2. AMENDMENT/MODIFICATION NO. Am-0003	3. EFFECTIVE DATE 23 August 2004	4. REQUISITION/PURCHASE REQ. NO.	5. PROJECT NO. (If applicable) KNMD013002A1
6. ISSUED BY CODE		7. ADMINISTERED BY (If other than Item 6) CODE	
U.S. Army Engineer District, Honolulu Corps of Engineers, Building 230 ATTN: CEPOH-CT-C (Joy Sakamoto) Fort Shafter, Hawaii 96858-5440

FY04 MILCON Project No. KNMD013002A1, Upgrade Electrical Distribution System, Phase 1/5, Hickam Air Force Base, Oahu, Hawaii

1. **CHANGES TO THE SOLICITATION.** Attached hereto are new and revised pages to specifications. Revised pages replace like-numbered pages. The revision mark “(Am-0003)” is shown on each new and revised page.

Figure 1. Construction Sign Example

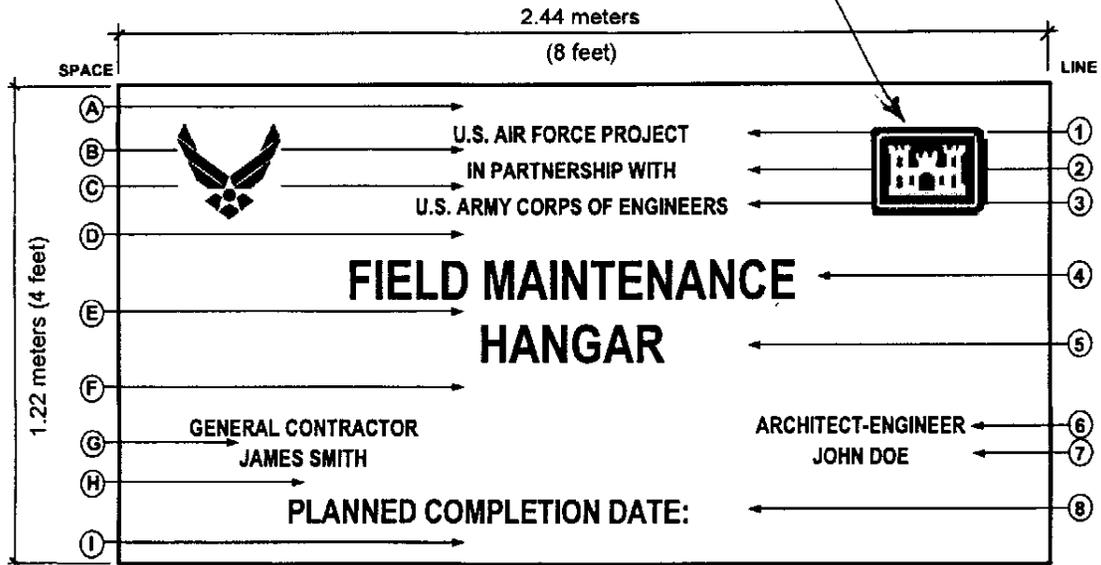
6.4. Details of sign graphics and construction are shown in Figure 1. Construct the sign using a 1.22-meter by 2.44-meter by 13-millimeter (4-foot by 8-foot by 0.5-inch) thick sheet of grade-AC exterior plywood.

6.5. Paint the sign with one coat of primer paint followed by two coats of gloss exterior-type enamel paint. The color must be either Standard Blue 15090 or Standard Brown 10100 as specified in Federal Standard (FED-STD) 595B, *Colors*, Volume 1. Lettering is to be as shown in Figure 1 in white gloss, exterior-type enamel.

DWG. NO. 40-21-07

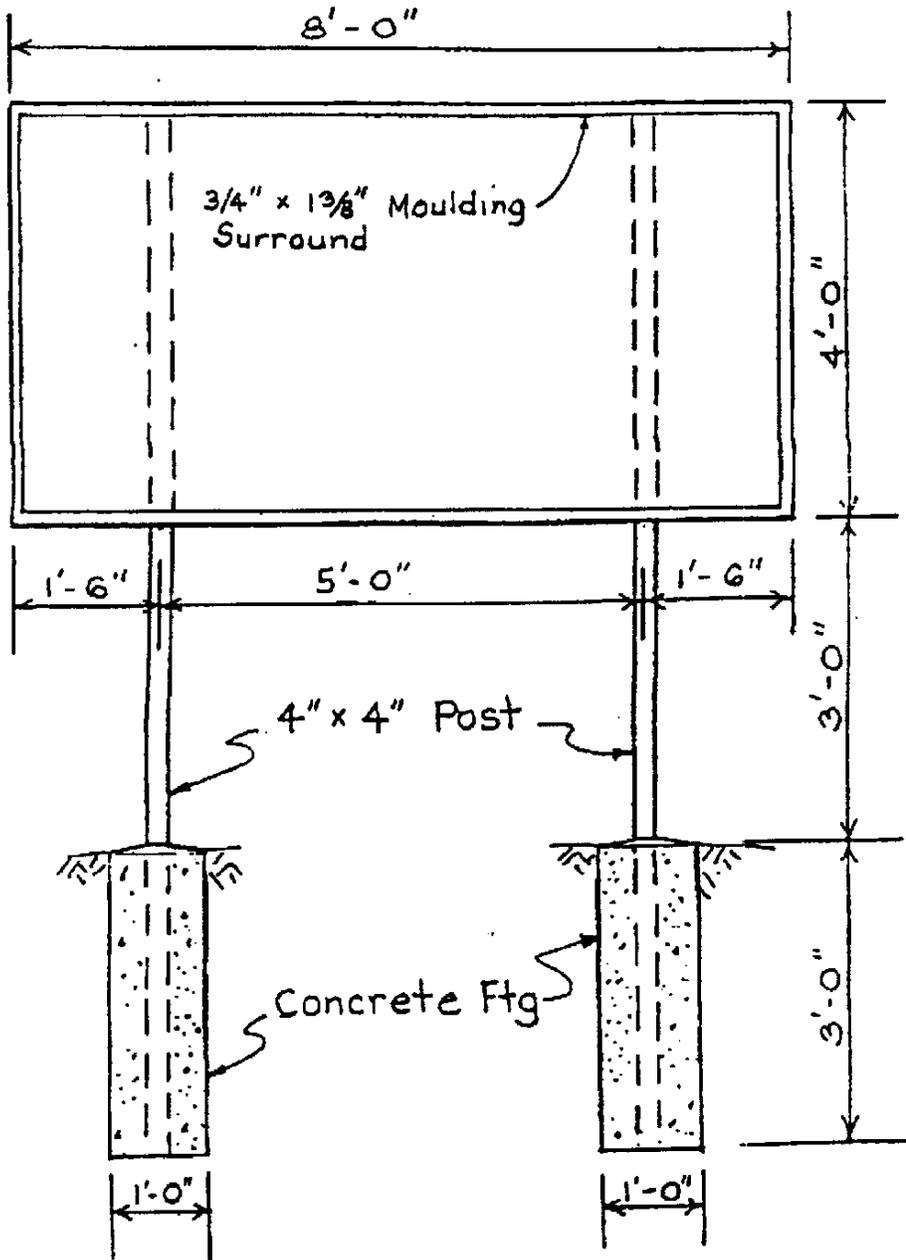
NOTE: CONSTRUCTION OF SIGN SHALL ALSO BE IN ACCORDANCE WITH ATTACHED ETC 02-09 (DATED MAY 15 2002)
